**Total Maximum Daily Load for Fecal Coliform for the Lower Salinas River  
Watershed,  
Monterey County**

**September 2, 2010, Item 18  
Staff Report Attachment 6**

**PUBLIC COMMENTS AND STAFF RESPONSE**

**Figure 1. Alisal Creek Watershed monitoring data, and FMMP grazing land spatial extent.**

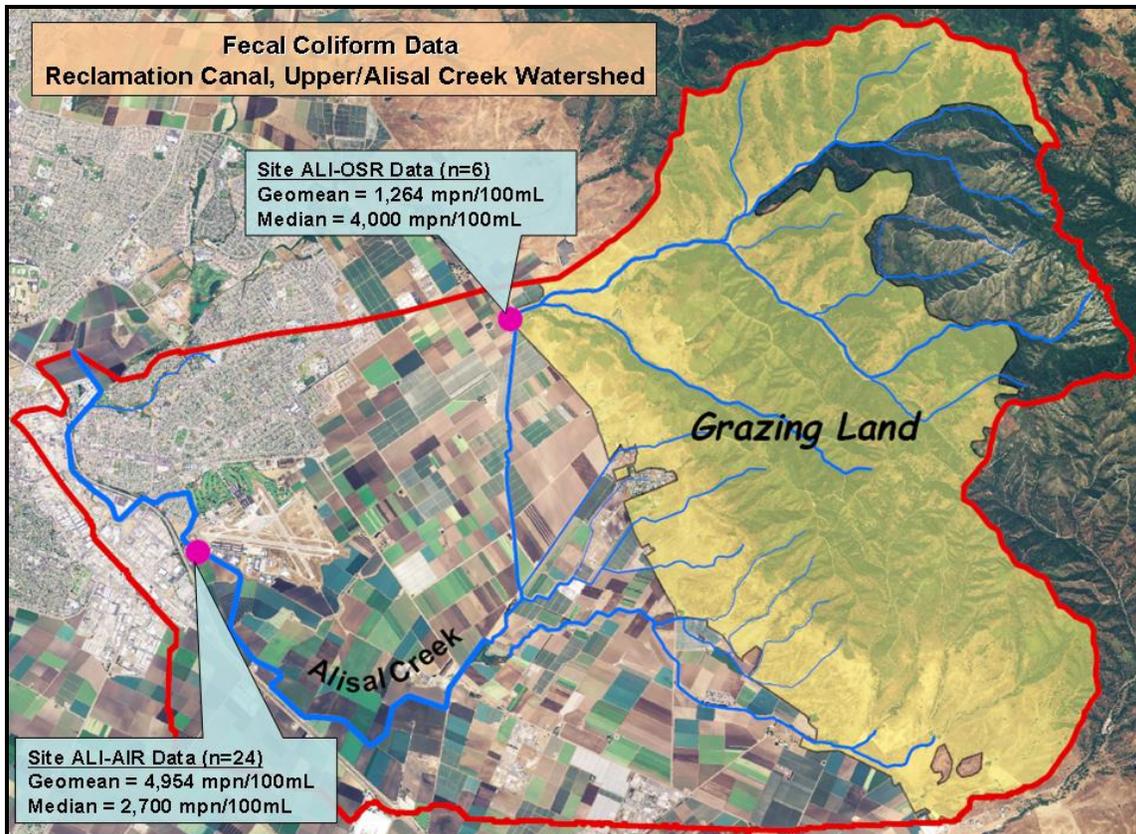
*I represent Tom and Terry Bengard of Salinas who have asked me to comment on their behalf regarding the Draft TMDL Project Report for Fecal Coliform for the Lower Salinas River Watershed ("the Report").... The Bengards' ranch is located east of Old Stage Road in the area of the headwaters of Alisal Creek. The Report includes the Bengard property in a subarea (Sub-Area 3b) that takes in the rural and undeveloped headlands of Upper Alisal Creek along with a significant urban and suburban area of the City of Salinas. The blending of these two areas is reflected in the title of the sub-area: "Salinas Reclamation Canal, Upper/Alisal Creek" (p. 13, Table 2-3). We contend that inclusion of the undeveloped upper Alisal Creek area with the lower urban/suburban area along the reclamation Canal incorrectly and unfairly tilts the analysis of fecal coliform concentrations present east of Old Stage Road, including the Bengard ranch. Figure 3-1 (p. 23) and Table 3-1 (p. 25) appear to confirm that no test sites were located east of Old Stage Road in the upper areas of Alisal Creek.*

With regard to the comment on monitoring data, please note that Water Board staff only collects stream data at locations with public access. Presumably, the upper reaches of the Alisal Creek watershed are on private property. However, there is monitoring data on Alisal Creek that captures grazing land drainage; please refer to Project Report Section 3.3 (Water Quality Data). Monitoring site ALI-OSR (Alisal Creek at Old Stage Road) reflects water quality data from drainages coming from the upper Alisal Creek catchments. As such, water quality from this site represents primarily grazing land runoff, with no urban, residential, or cropland inputs. Please refer to Figure 1.

Figure 1 shows the spatial extent of grazing land in the Alisal Creek watershed. The grazing land spatial data depicted in Figure 1 come from the Farmland Mapping and Monitoring Program (FMMP - California Dept. of Conservation, 2005). FMMP, in cooperation with the California Cattlemen's Association and others, developed digital mapping data depicting the location and extent of grazing lands. As such, this map illustrates that monitoring site ALI-OSR drains predominantly grazing lands. Monitoring data for fecal coliform is annotated on the map.

The fecal coliform concentrations in water quality samples for ALI-OSR significantly exceeded the REC-1 water quality screening objective (400 mpn/100mL); also, three of six samples (50%) from ALI-OSR also exceeded the much less stringent REC-2 (i.e., the non-water contact recreational use) water quality screening standard (4000 mpn/100mL). Note that the data from ALI-OSR contrasts with water quality data the Water Board has collected from undeveloped watersheds that are dominated by forest and native grass and that are devoid of any significant anthropomorphic or domestic animal operations. Indicator bacteria

Figure 2. Selected CCAMP Monitoring Sites, and Grazing Land and Forest Distribution (FMMP Dataset), Monterey County.

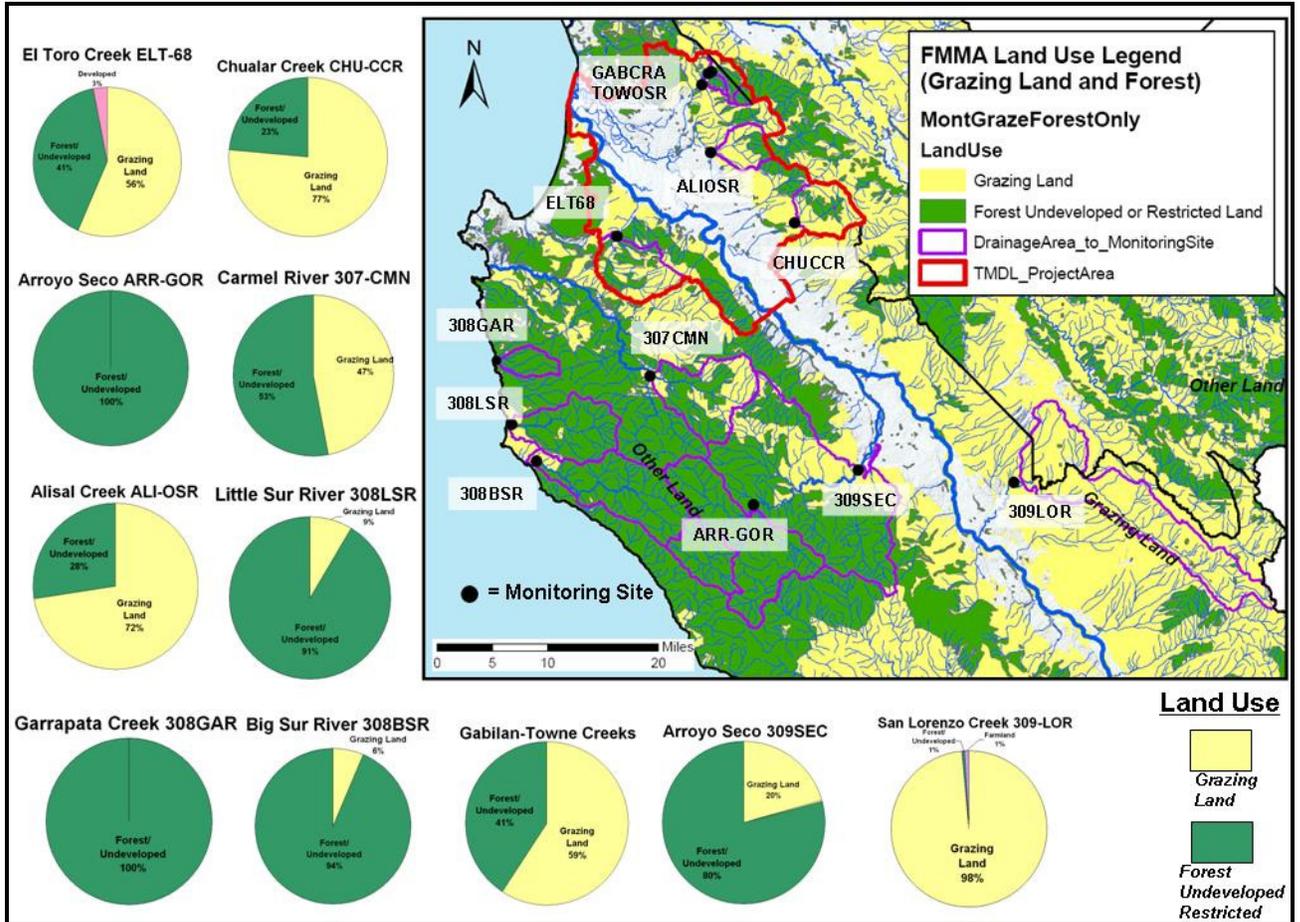
- *Comment: “Analyze and evaluate the data of Southern Monterey County ( Arroyo Seco watershed). This is where land use is livestock/commercial and where RWQCB Staff there is NOT an exceedances of fecal coliform loads”*

Consequently, staff evaluated water quality conditions from monitoring sites in Monterey County which drain only grazing lands and/or forest and undeveloped lands (i.e., monitoring sites where there are zero, or negligible urban, residential or cropland inputs). The results are presented in Figures 2 and 3.

Figure 2 illustrates the spatial extent of grazing land and forest/undeveloped lands in Monterey County, with selected CCAMP water quality monitoring points annotated on the map.

Bubble charts shown in Figure 2 depict the proportion of grazing lands versus forest/undeveloped lands in the catchments draining to each individual monitoring site. As the bubble charts show for this selected suite of monitoring
